GeoConcepts, Inc.
Geology • Geotechnical Engineering

Project 1680

Subject: **SUPPLEMENTAL REPORT No. 4**
23401 Civic Center Way,
Malibu, California

Description:
 Geologic Map
 Issued For:
 Whole Foods

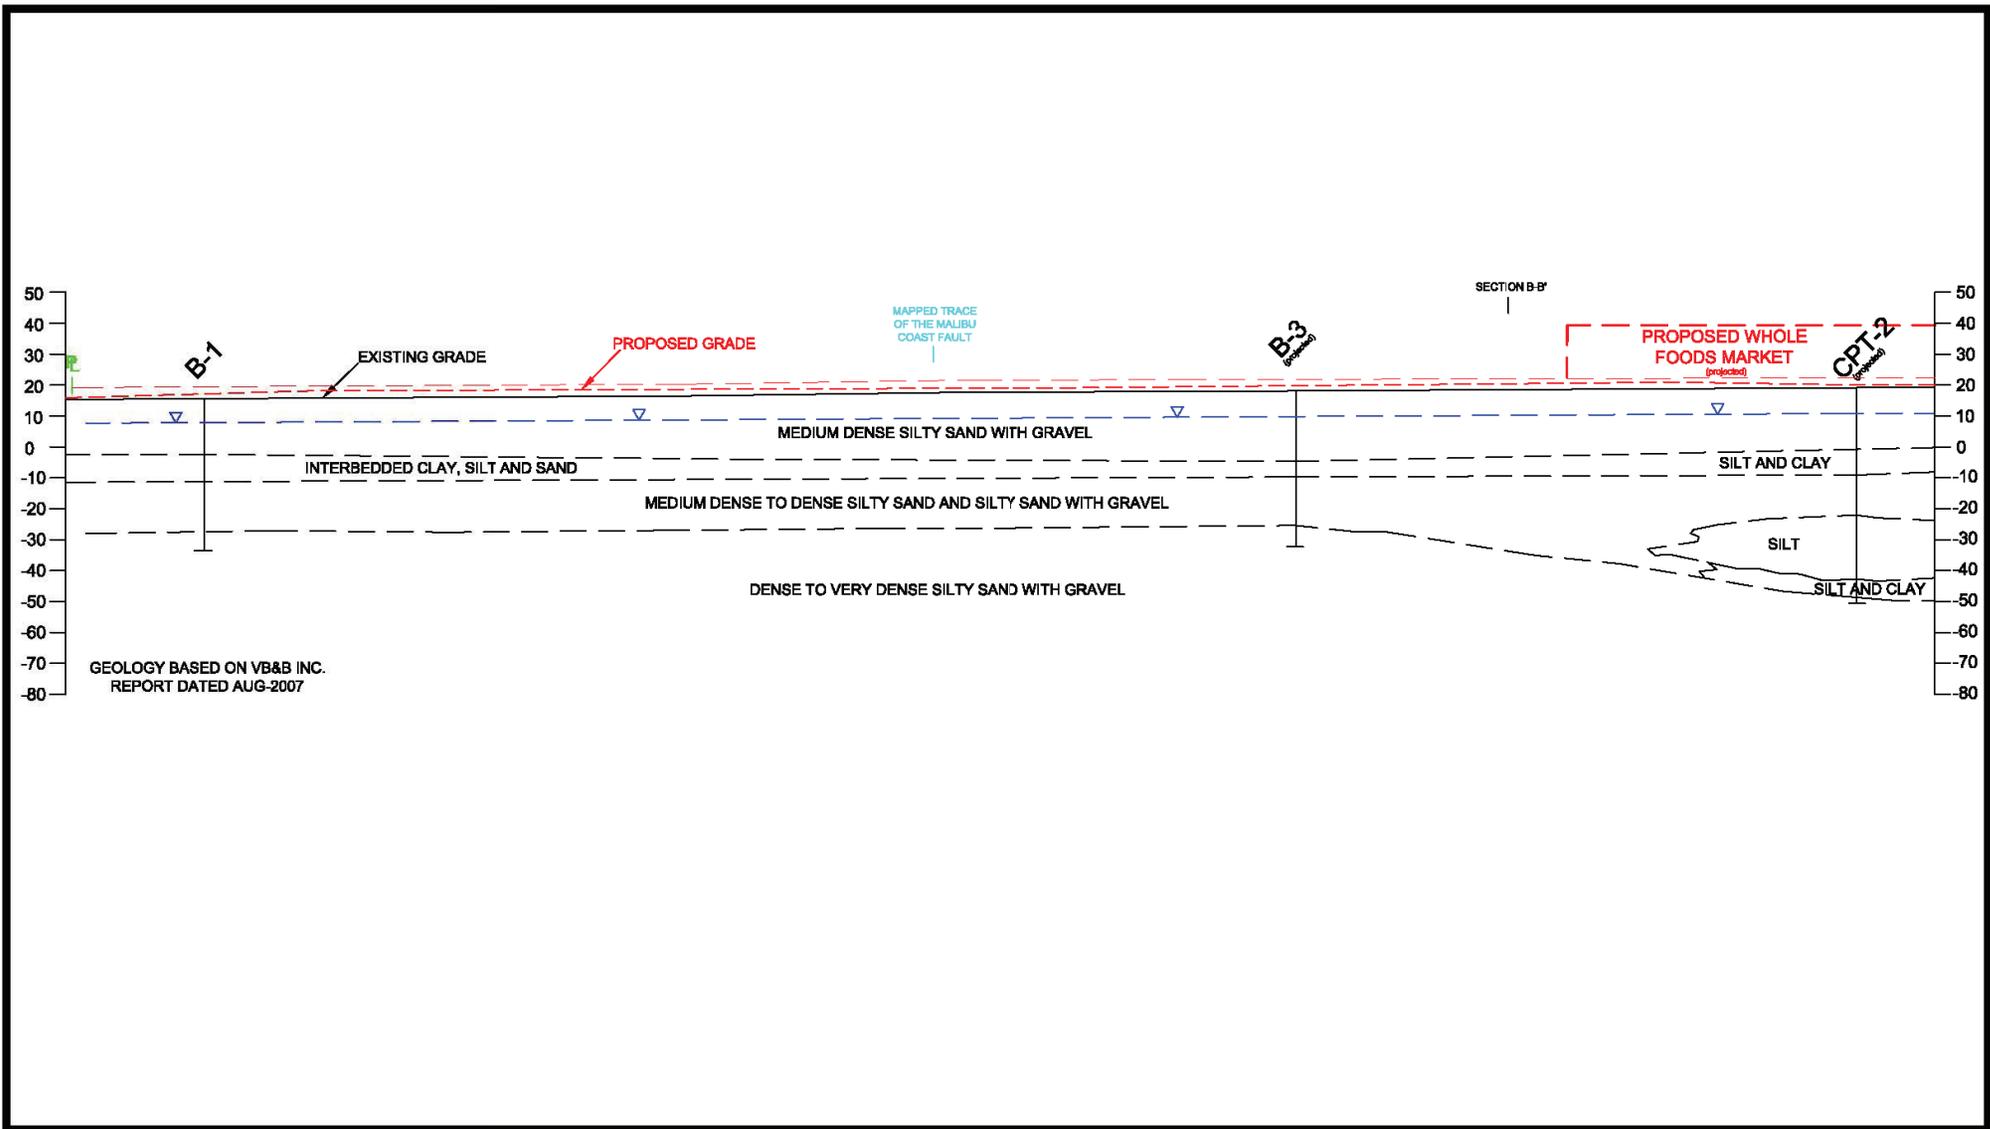
1. The undersigned engineering geologic reviewer acknowledges that seismic trenching may not provide enough data to accurately determine the fault rupture potential across the site given the shallow groundwater levels and the relatively young ages of the near-surface stratigraphic units. However, discussions regarding continuity and age of lithologic units under the site, based on the boring data and pertinent reports on adjacent properties, have not been provided. When trenching is not practical, other methods of investigating fault rupture potential shall be utilized. Please evaluate the continuity of lithologic units across the site and the ages of these sediments. CPT data from the site and adjacent properties may be utilized in the evaluation. What additional evidence supports the Project Geotechnical Consultant's conclusion that, "...no known active fault is anticipated to daylight beneath the limits of the proposed structure."?

Previous seismic trenching performed on the site is depicted on the attached geologic map. On site seismic trenching is extremely limited by the very shallow depth to groundwater and the very young sediment above the groundwater. However, it is believed that adequate seismic trenching covers the proposed development for the following reasons; According to the report by the California Division of Mine and Geology Fault Evaluation Report FER-229 dated October 3, 1994 of the Malibu Coast Fault, "There is no known evidence of Holocene displacement on the main trace of the Malibu Coast fault."

On August 16, 2007, the fault zone near the east side of Malibu Bluff Park was removed from the State of California Earthquake Fault Zone map by the California Geologic Survey. Clearly, the State of California and private consultants agree that no evidence of active faulting on the Malibu Coast fault within the Malibu Civic area is known. Because these very extensive investigations on the Malibu Coast Fault concluded that the Malibu Coast is inactive in the Malibu Civic Area, adequate seismic trenching covers the proposed development on the subject site.
